REGIONAL REVIEW FINDING

ARC REVIEW CODE: R509302

Submitting Local Government: Cobb County
Name of Proposal: The Mill at Covered Bridge Expansion

Preliminary Report:	Sept 30, 2005	DEVELOPMENT OF REGIONAL IMPACT REVIEW REPORT	Project:	The Mill at Covered Bridge Exp #911
Final Report Due:	Oct 30, 2005		Comments Due By:	October 14, 2005

Boulevard Detail (Typ.)
(56' T/W)

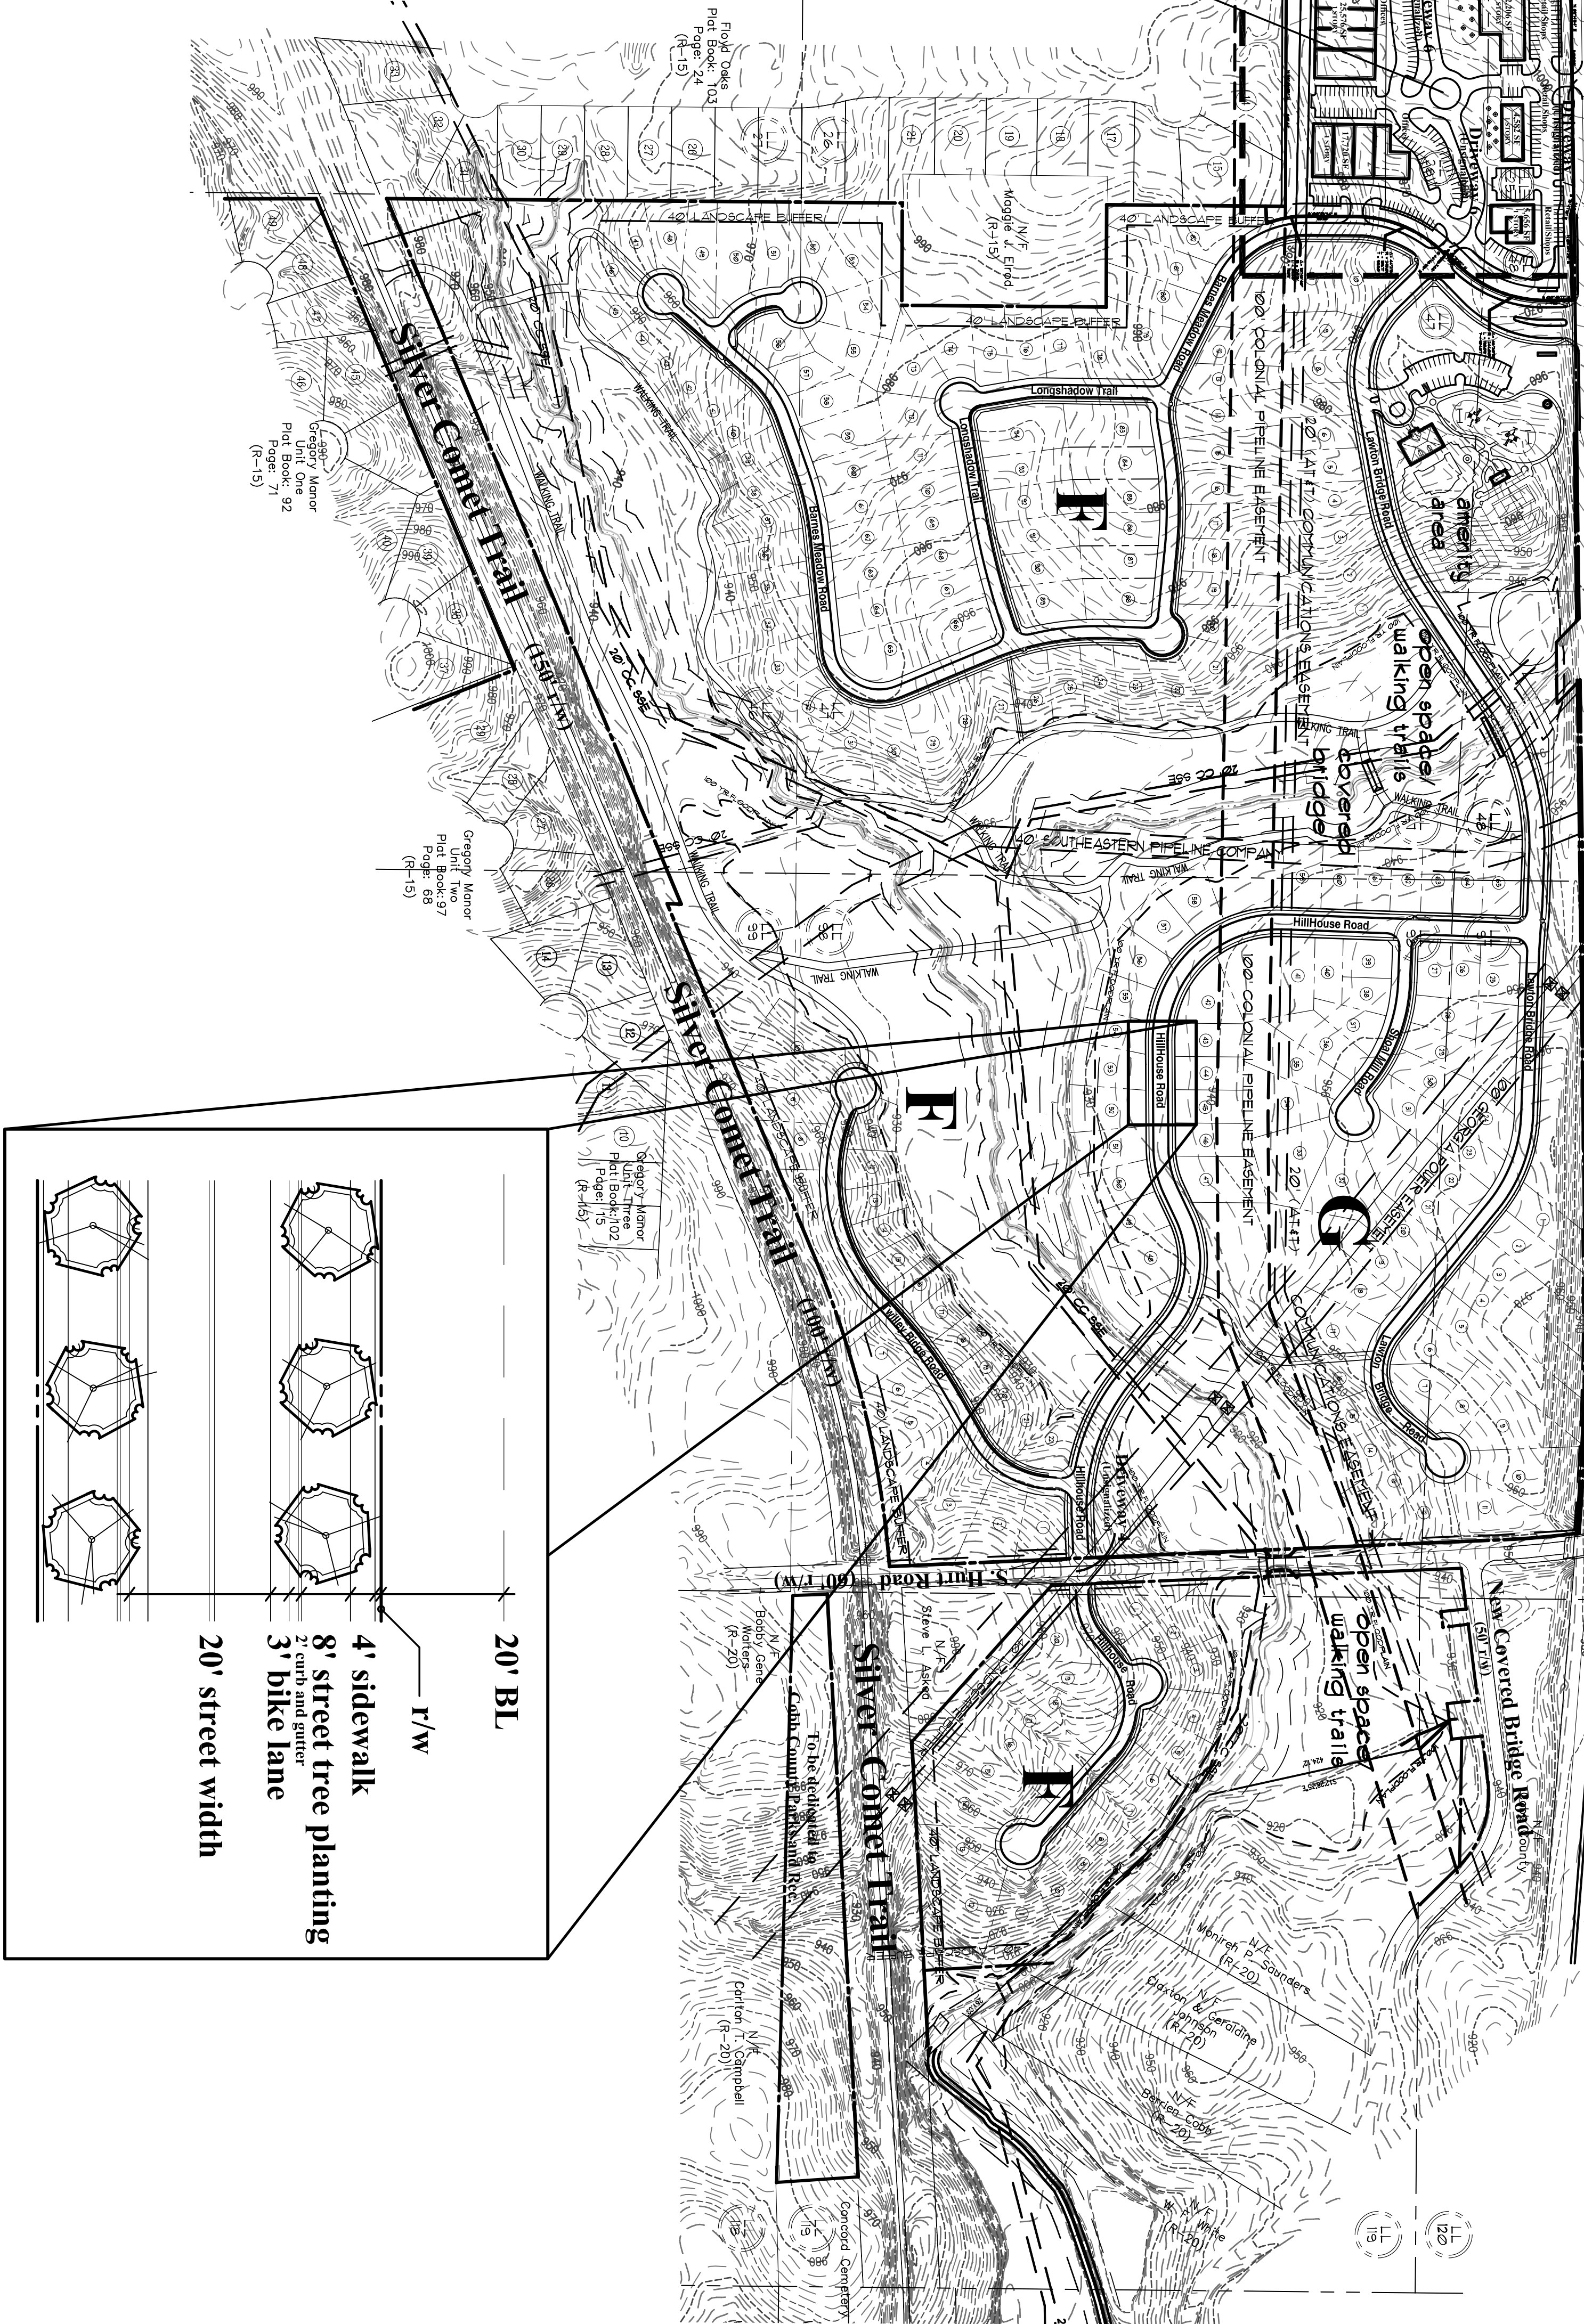
Additional Comments: The proposed expansion provides good connections to the residential portions of the site that are located adjacent to the proposed expansion. Minimizing the appearance of parking from Hicks Road and East West Connector is strongly encouraged. Safe and convenient pedestrian access should be provided throughout the parking areas.

The proposed expansion provides good connections to the residential portions of the site that are located adjacent to the proposed expansion. Minimizing the appearance of parking from Hicks Road and East West Connector is strongly encouraged. Safe and convenient pedestrian access should be provided throughout the parking areas.
